BENDIX STREET, MANCHESTER

**REPORT TO DISCHARGE DRAINAGE
RELATED PLANNING CONDITION**

Report Title: Report to Discharge Proposed Drainage Related Planning Condition

Report Reference: BST-RDG-00-ZZ-RP-C-0002

TYPICAL DETAILS OF ATTENUATION TANK BASED ON ALDERBURGH PLUVIAL CUBE MODULE UNITS

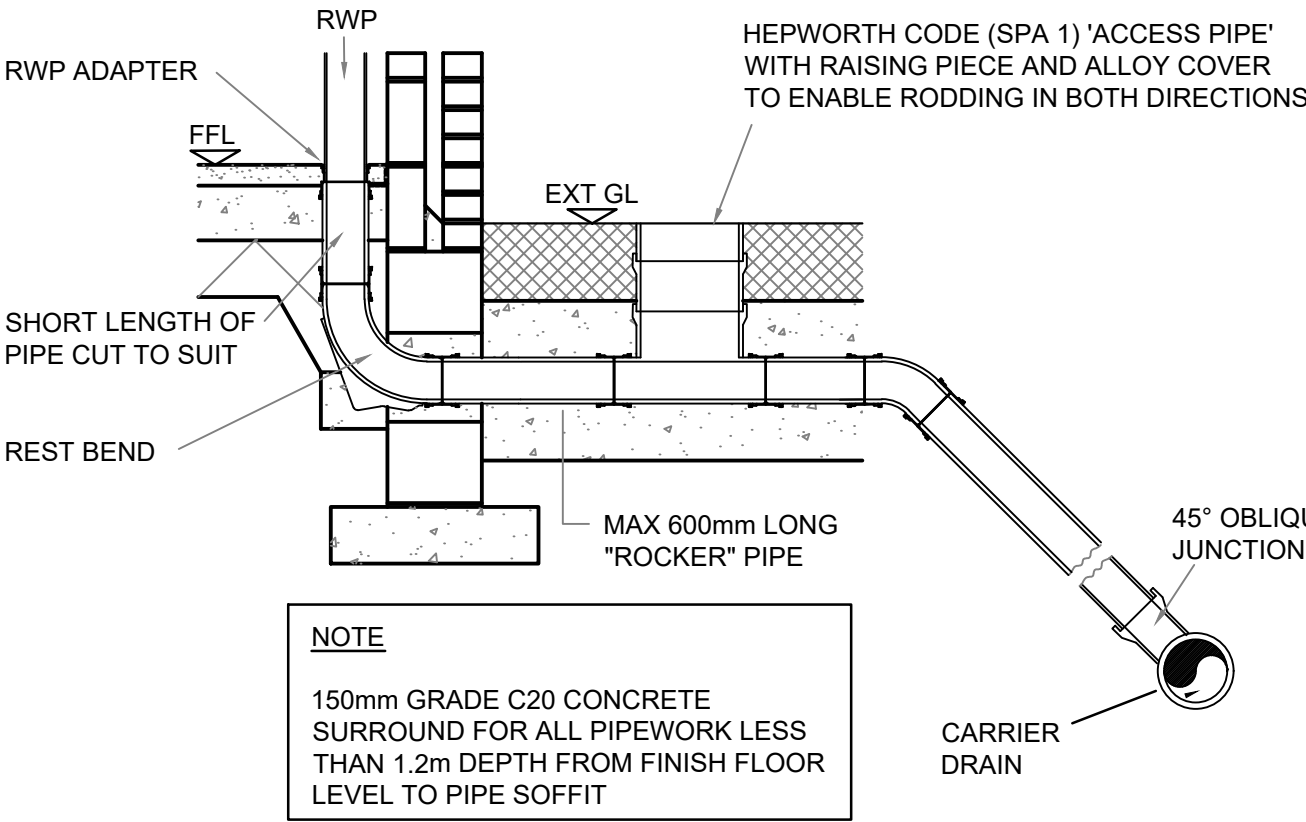
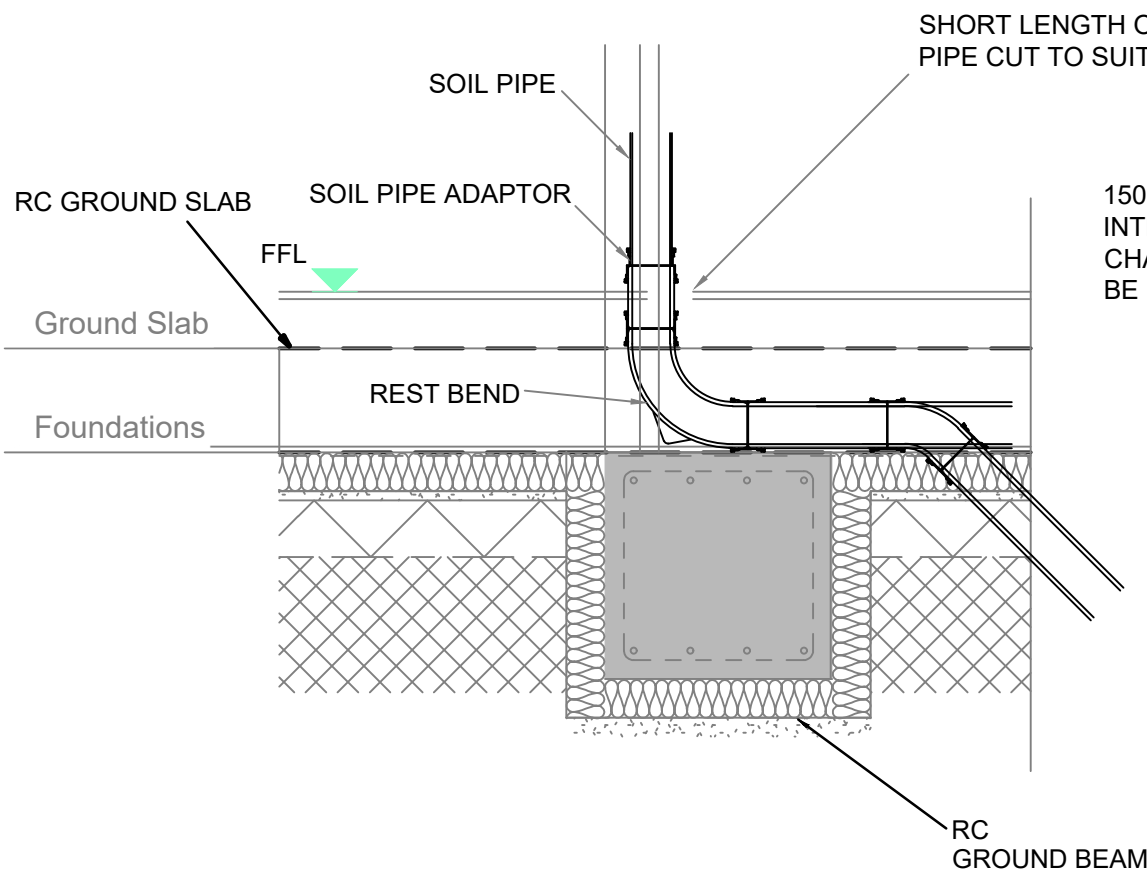
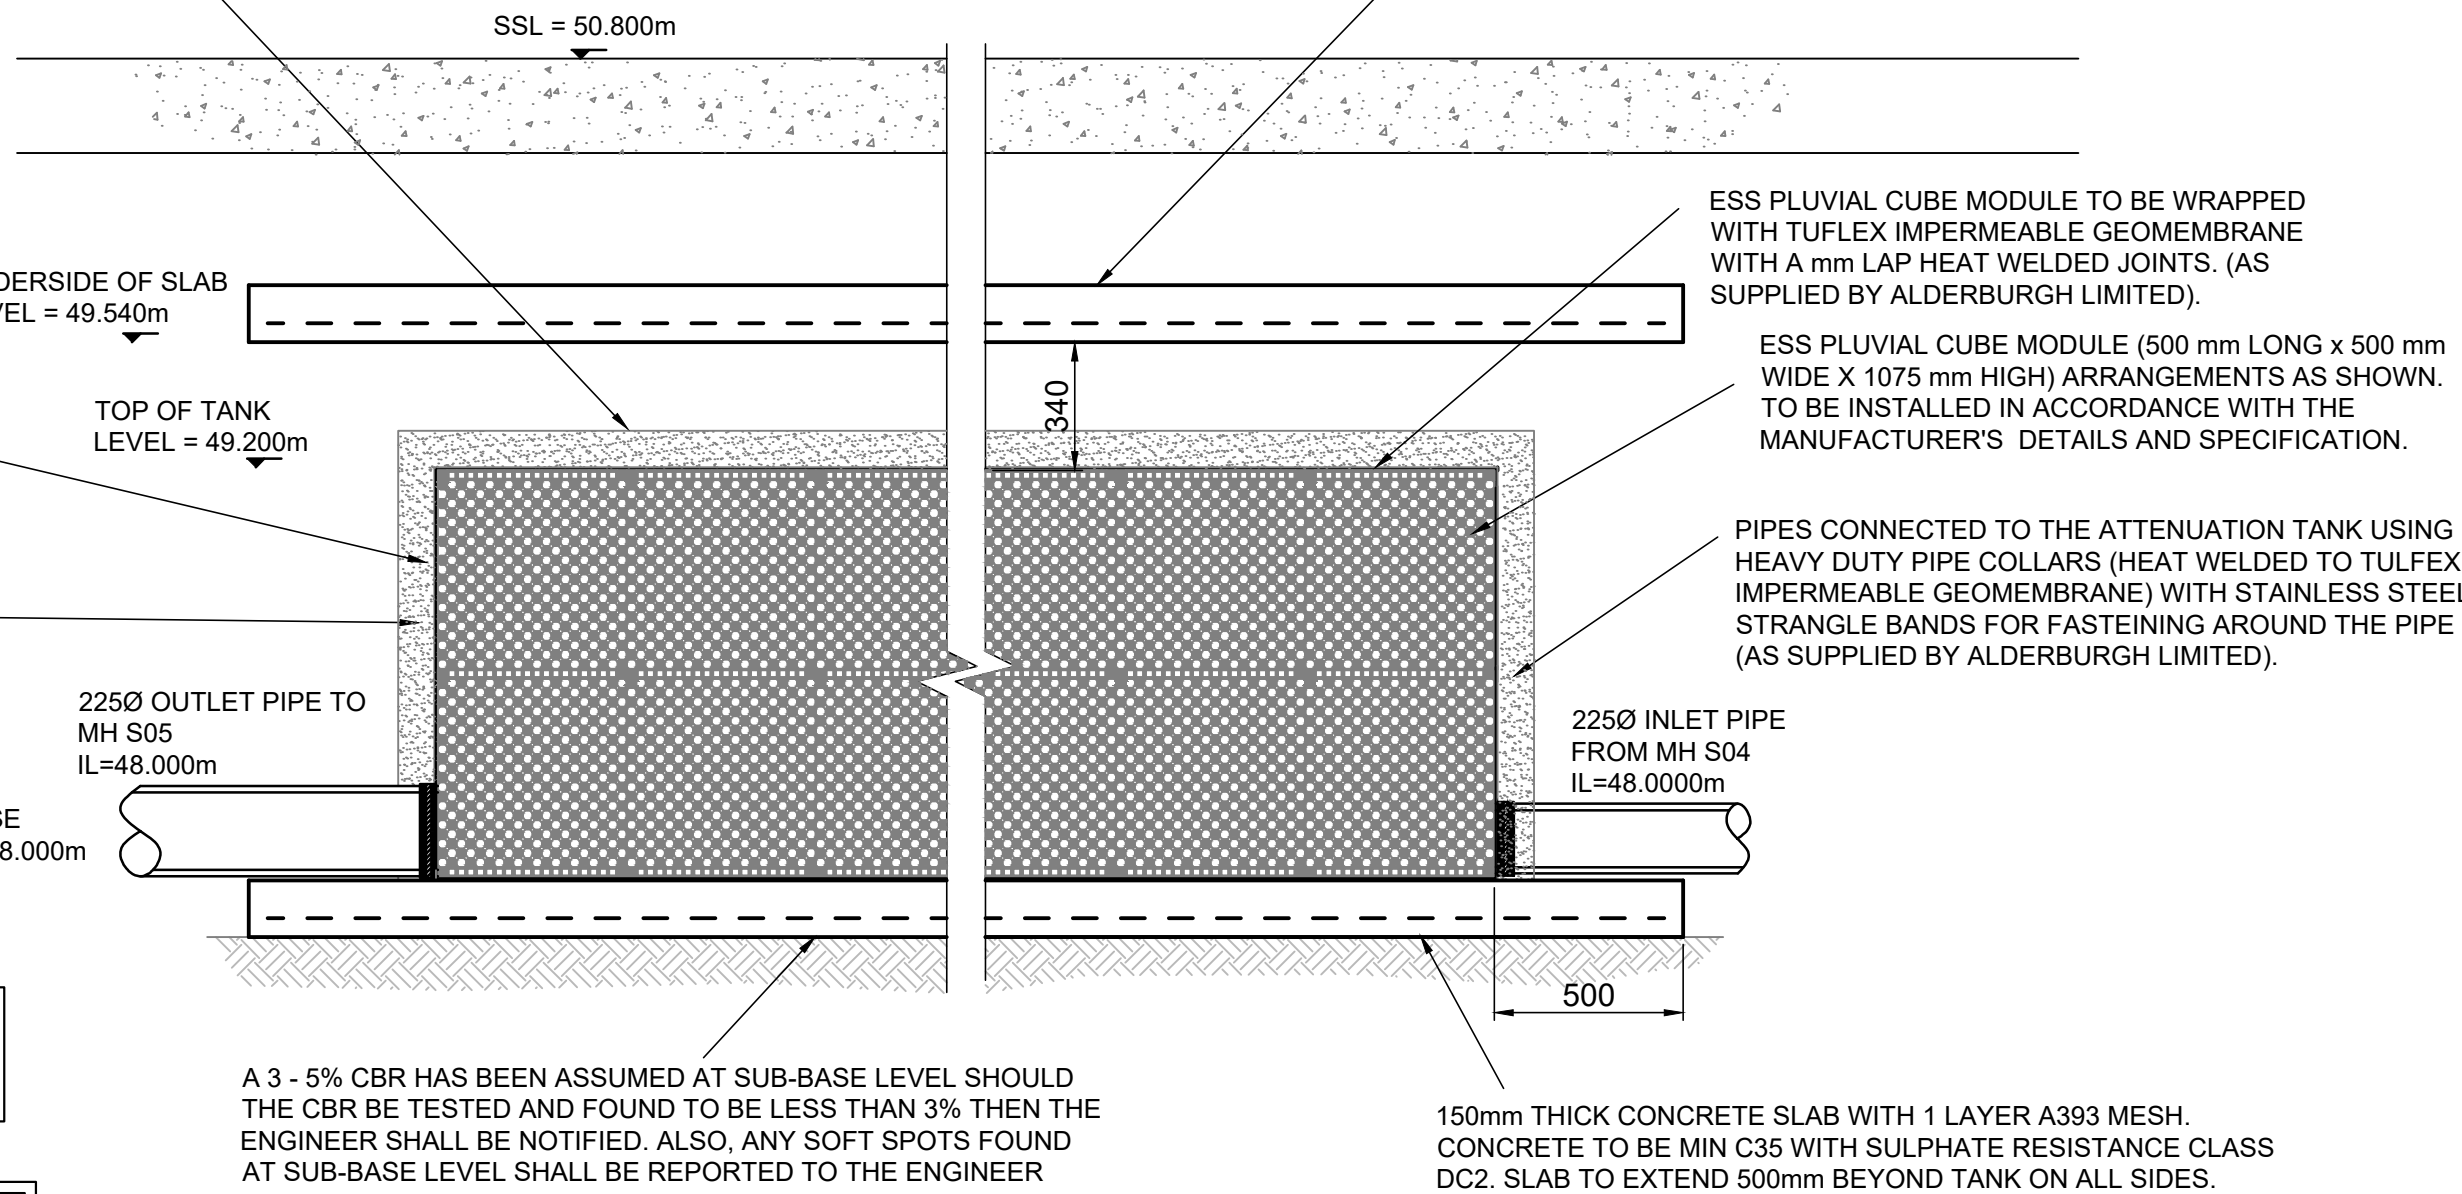
- *Construction details of flow control and SuDS elements*

For construction details refer to drawings BST-RDG-00-ZZ-DR-C-0102 & 0103 in Appendix A.

CLIENT	MULBURY HOMES Ltd		
PROJECT	BENDIX STREET, NEW CROSS,MANCHESTER		
DRAFTER	AS	ENGINEER	EJD
TITLE	FLOOD ROUTE PLAN		
		PROJECT REFERENCE:	
SCALE	SHEET	DRAWING No	REV
1:100	A1	BST-RDG-00-ZZ-DR-C-0105	P1

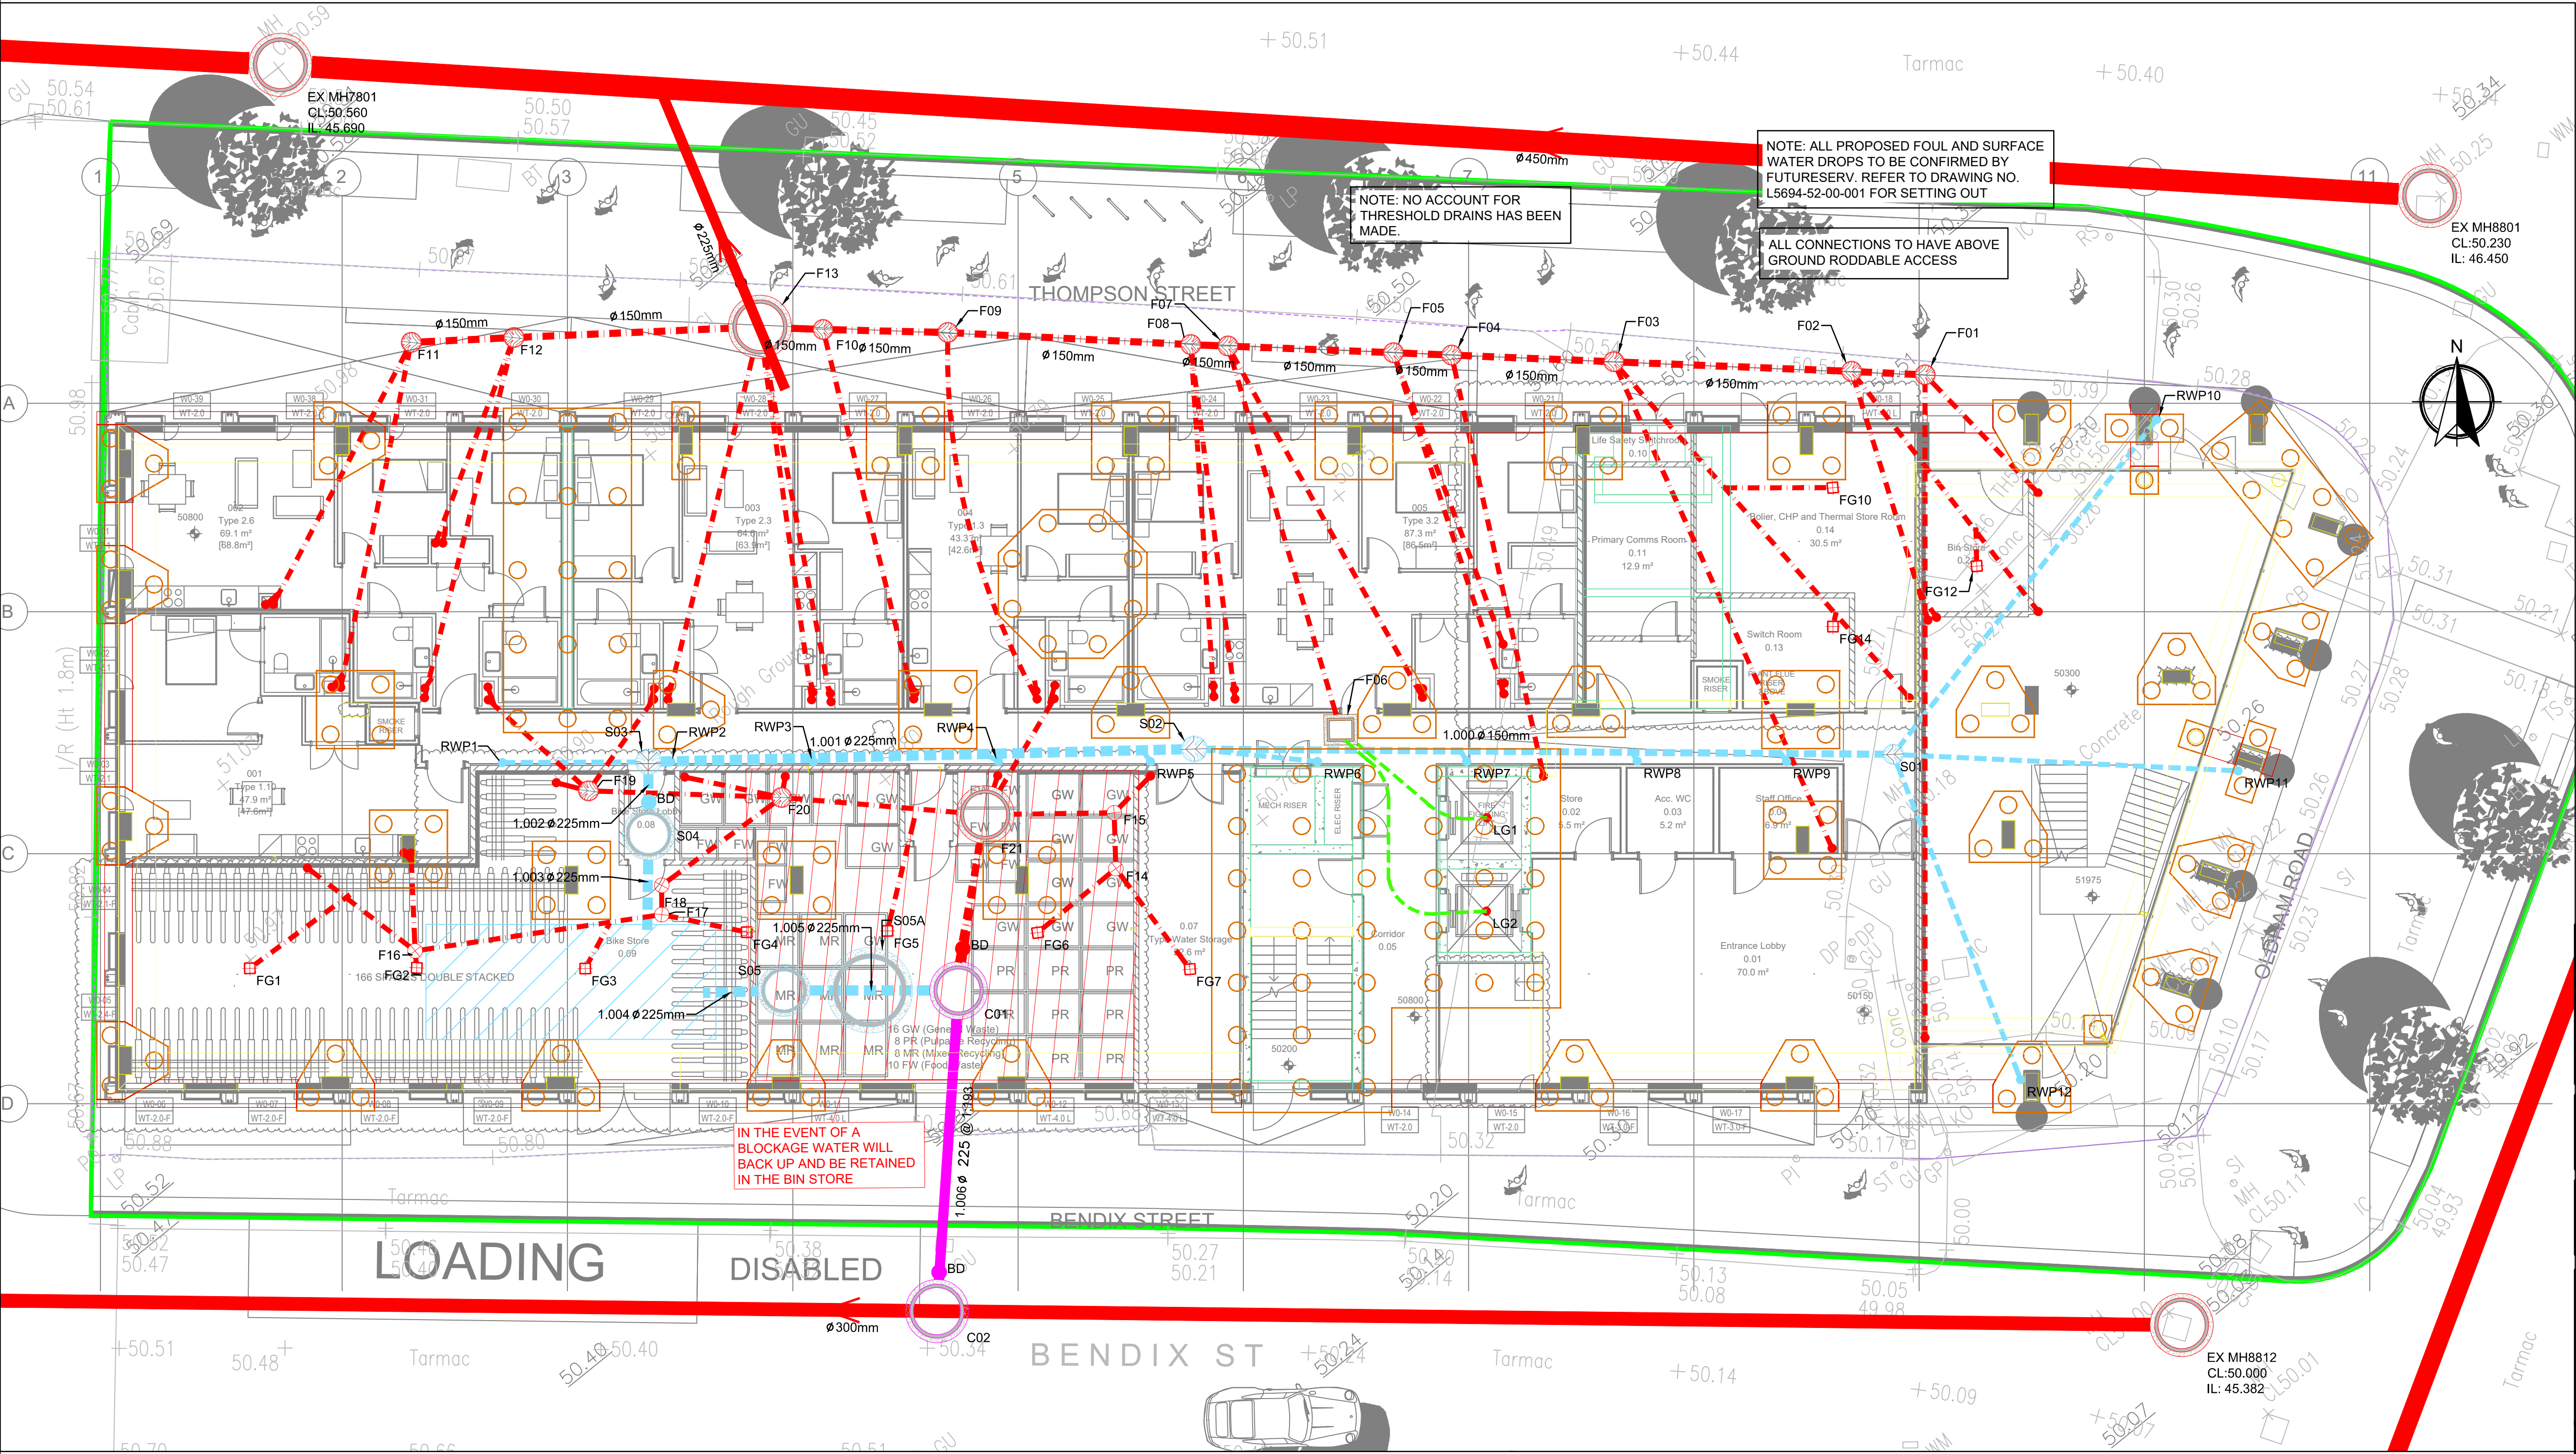
- *Assessment of overland flow routes for extreme events that is diverted away from buildings (including basements). Overland flow routes need to be designed to convey the flood water in a safe manner in the event of a blockage or exceedance of the proposed drainage system capacity*

including inlet structures. A layout with overland flow routes needs to be presented with appreciation of these overland flow routes with regards to the properties on site and adjacent properties off site.

The proposed building covers the whole site, as such the surface water drainage has been designed with no exceedance flooding. In the event of a blockage, flood waters will be contained within the cycle storage which encompasses the majority of the below ground drainage networks. No habitable areas of the proposed development will be impacted. The FFL of the building is elevated in relation to the surrounding footway – no surface water from the footway is diverted towards the building.
